**ASSESSMENT OF
ENVIRONMENTAL ISSUES
FOR THE PROPOSED
KYOTO ENERGY PARK –
AVIATION**

Client	Pamada Pty Ltd
Contact	Mark Dixon
Document No	2621/PR/004
Issue No	C
Status	Final
Classification	Client's Discretion
Date	28 August 2008

Response to Aviation Issues
from the Department of Defence
(12 March 2008)

PROPOSED KYOTO ENERGY PARK - SCONE NSW

Figure 5 29RNAV sloping protection surface overlaid with terrain surface + 150m (revised 42 turbine layout)

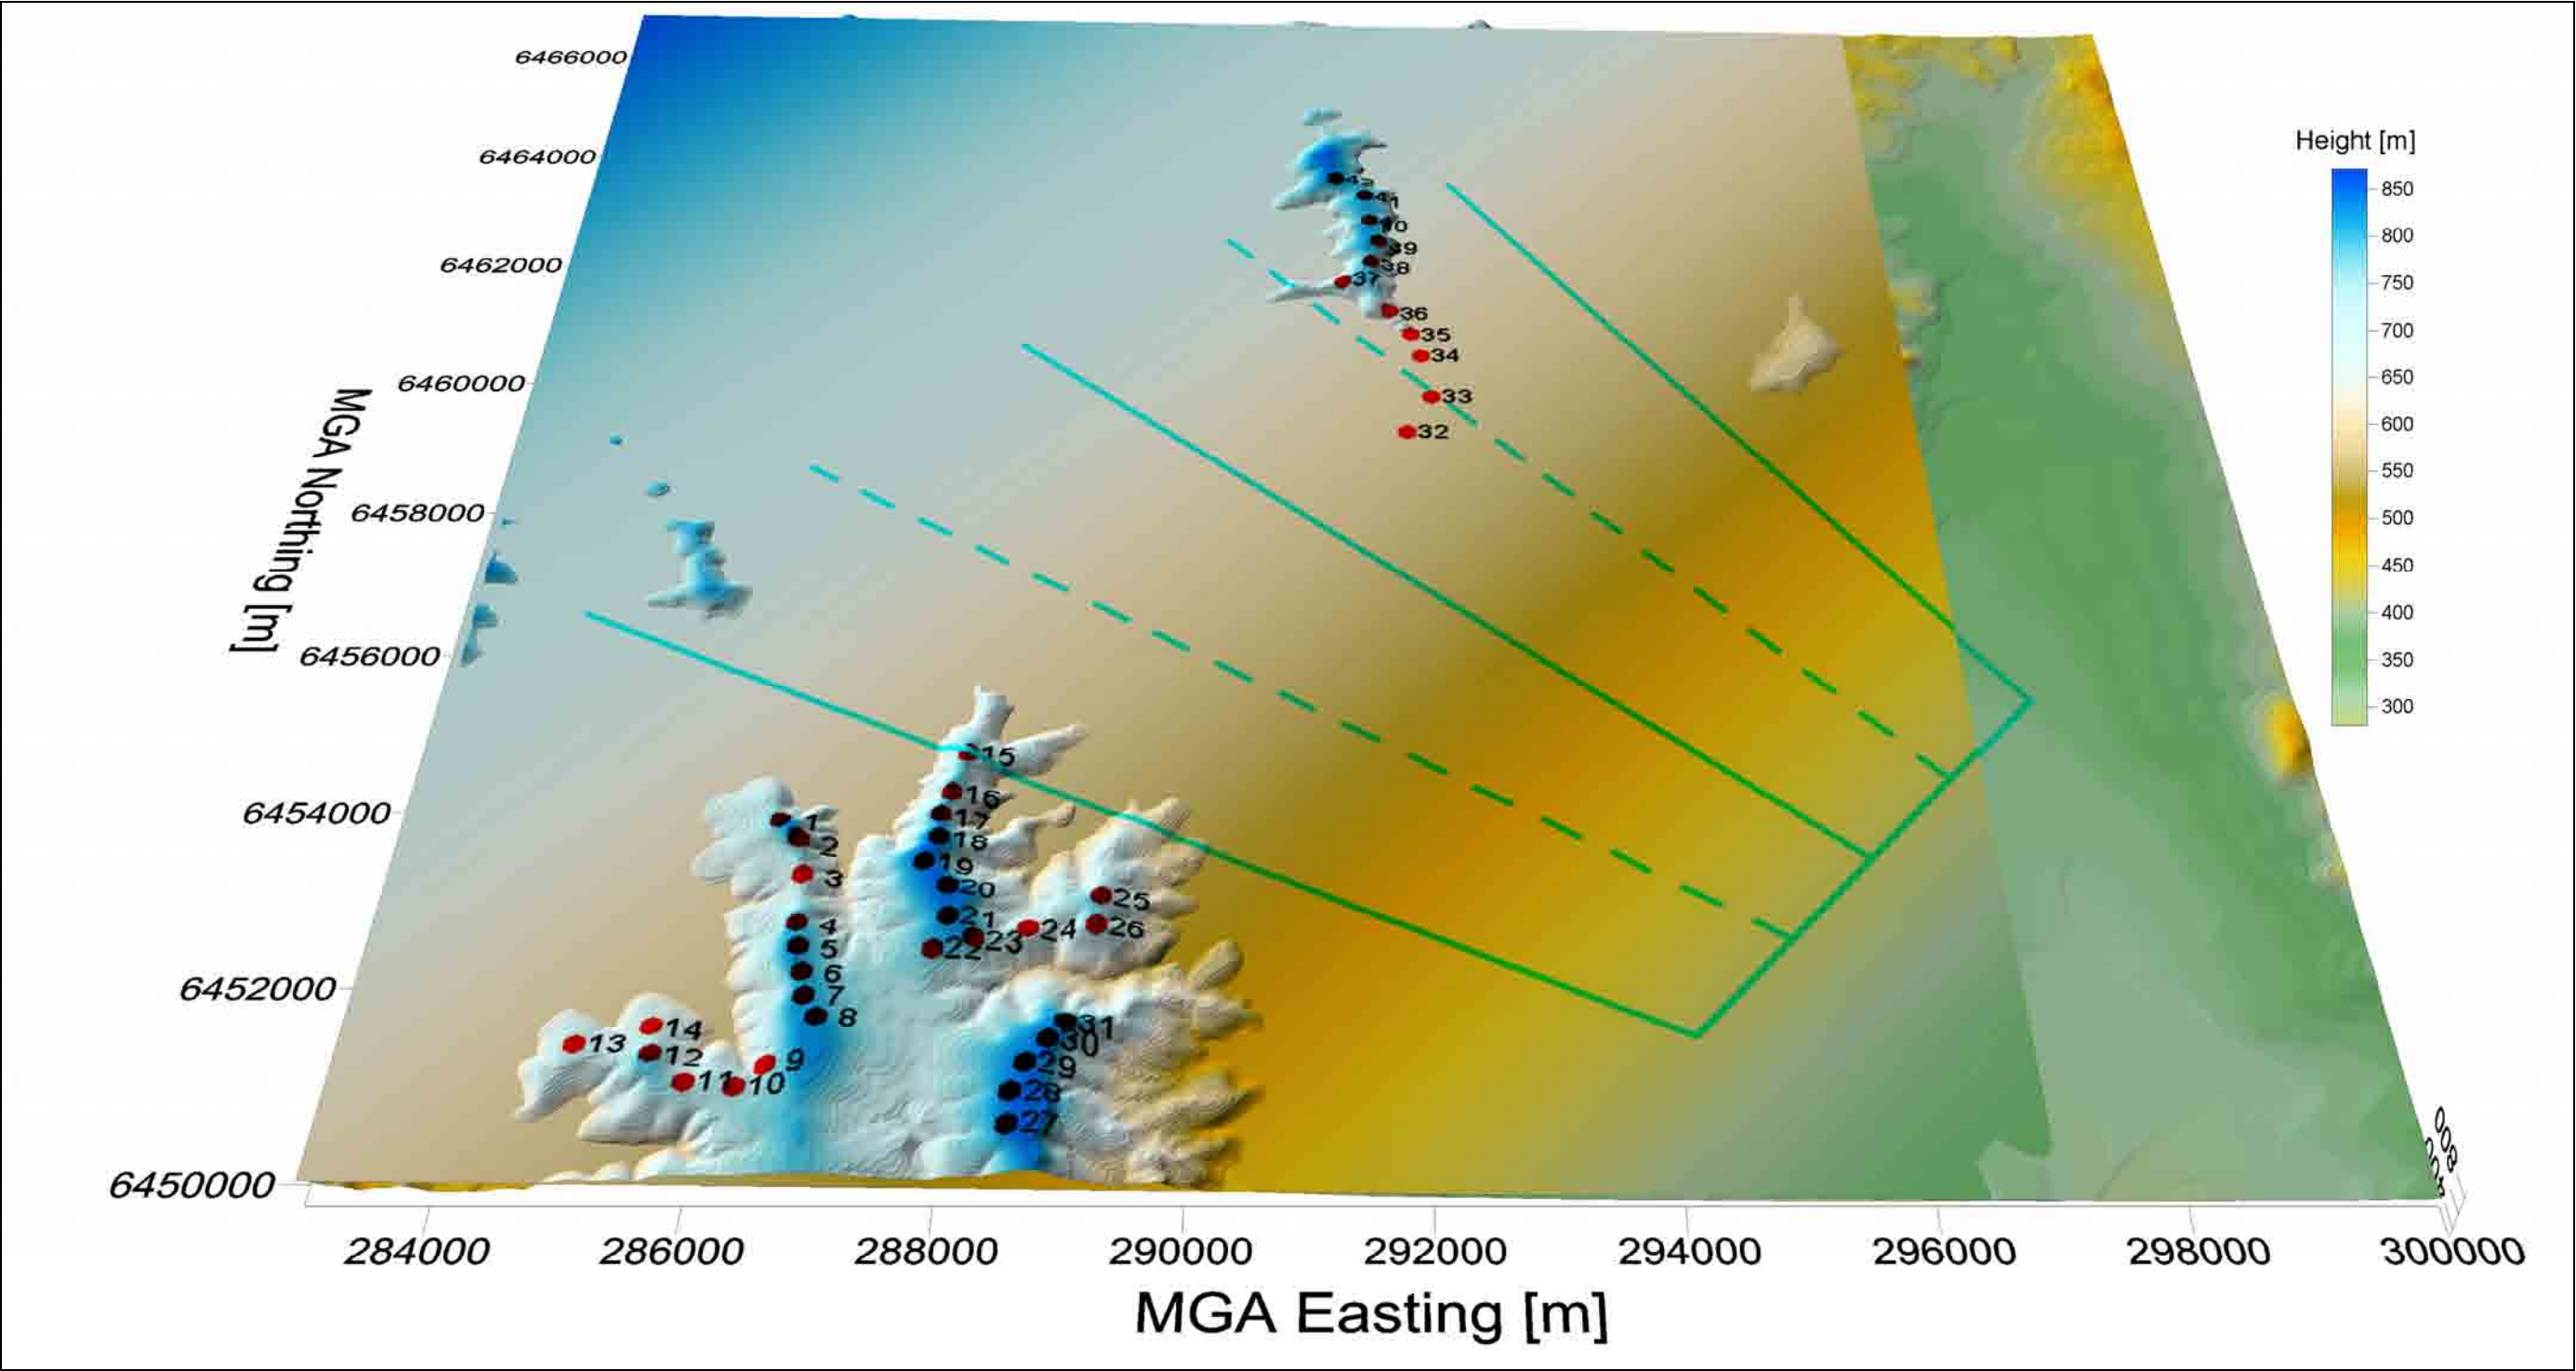
Airservices Australia indicated that in the old layout, turbines 15 and all those north of turbine 39 inclusive (39,40, 41, 42, 43, 44, 45, 46 and 47) infringe the 29RNAV procedure [7]. GH concurred with this finding.

The revised layout for the proposed Kyoto Energy Park project has incorporated an 80m move south to turbine 15 which sees it no longer infringing the 29RNAV procedure. With this revised layout, turbines 36, 37, 38, 39, 40, 41 and 42 are left infringing the 29RNAV procedure.

Figure 6 NDB approach protection procedure.

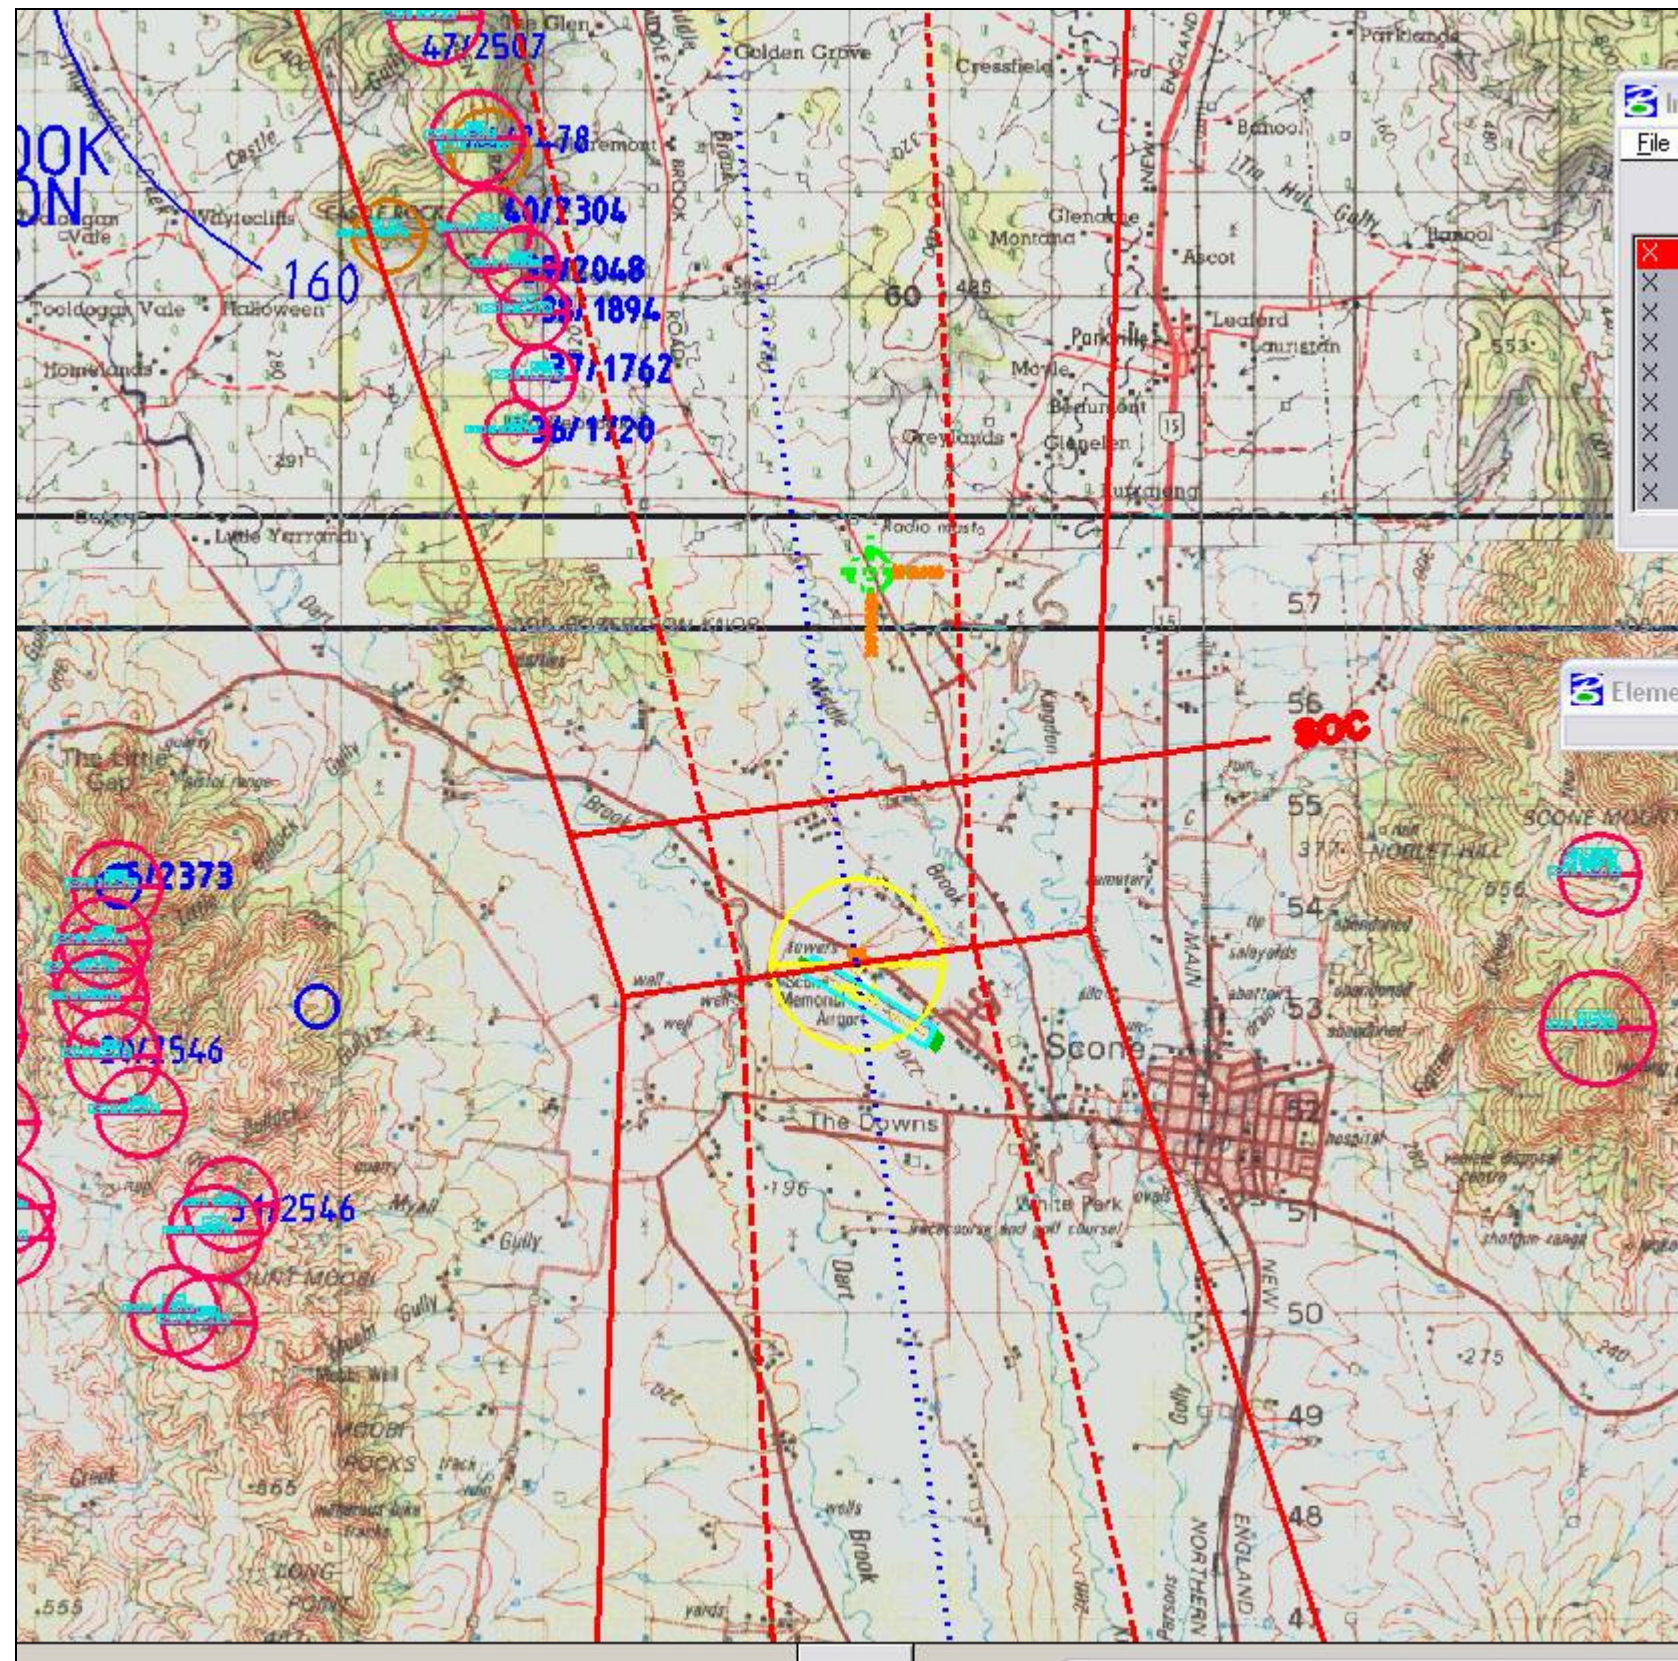
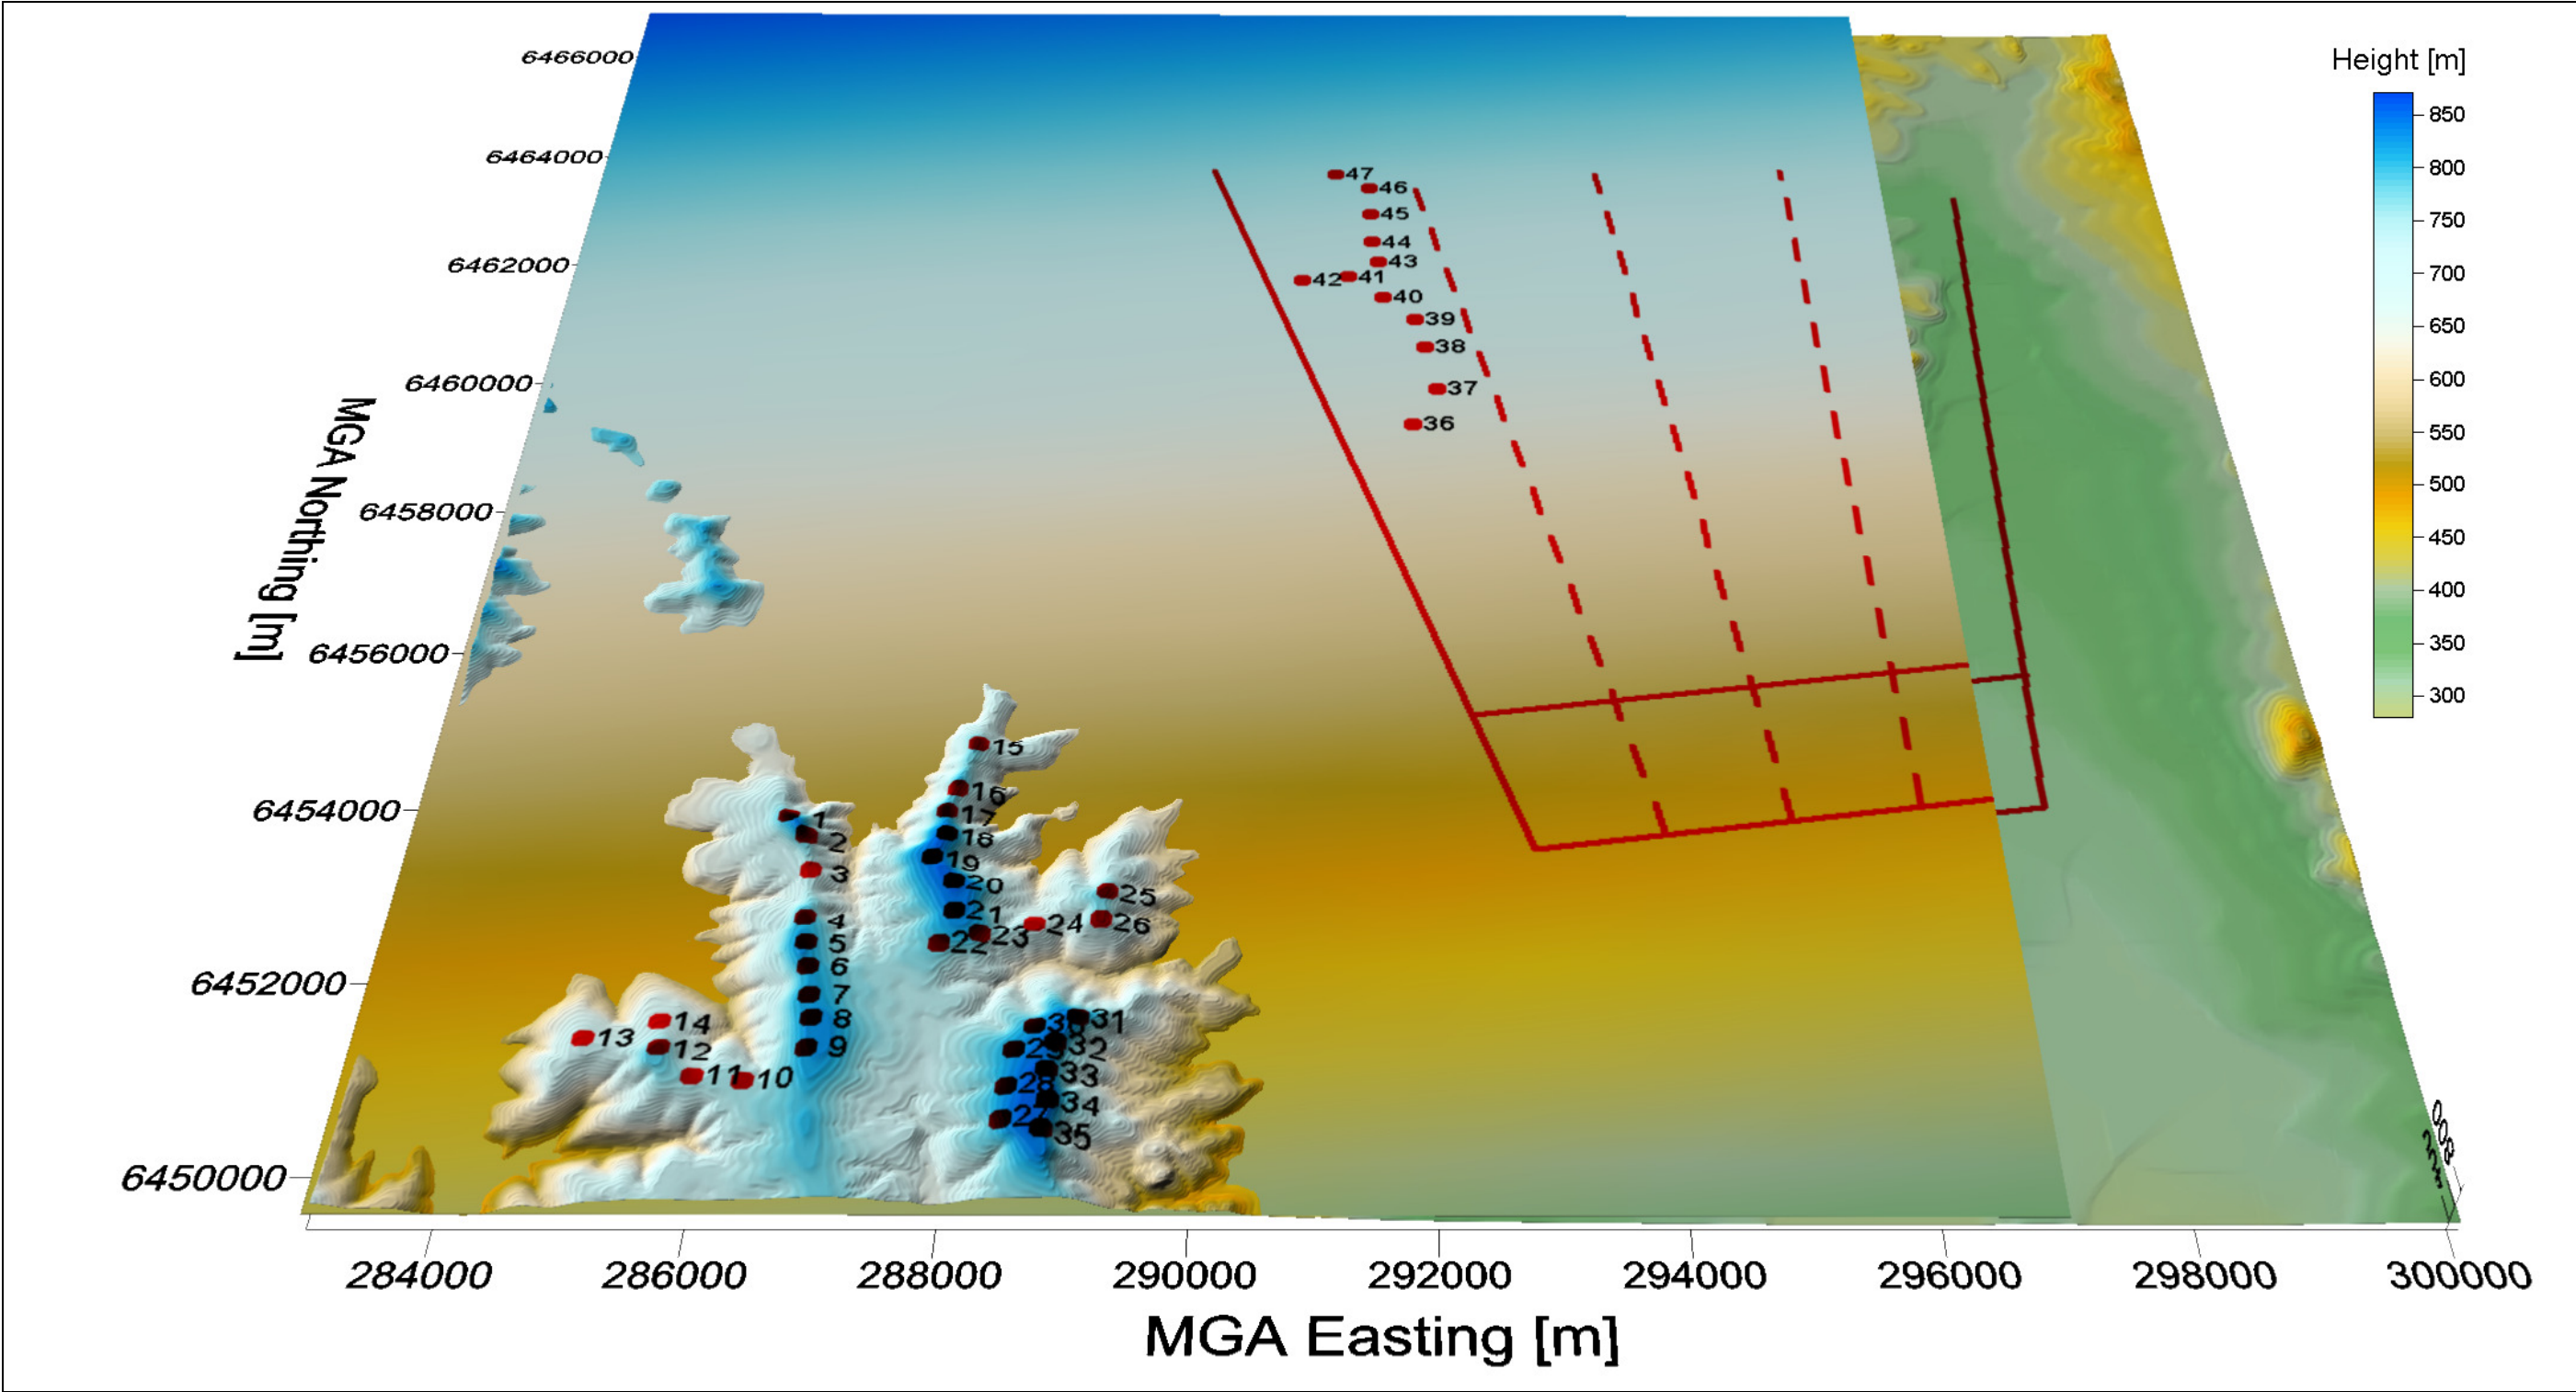
Airservices Australia indicated that turbine 40 from the old layout infringed the NDB procedure [7]. GH could not confirm this within the accuracy of our modelling process, however this finding is superseded by the fact that turbine 40 from the old layout already infringed the 29RNAV procedure as detailed above.

In the revised 42 turbine layout, turbine 36 is closest to turbine 40 in the old layout. GH could not confirm within the accuracy of our modelling process that turbine 36 from the revised layout infringed the NDB procedure, however this finding is superseded by the fact that turbine 36 already infringed the 29RNAV procedure as detailed above.
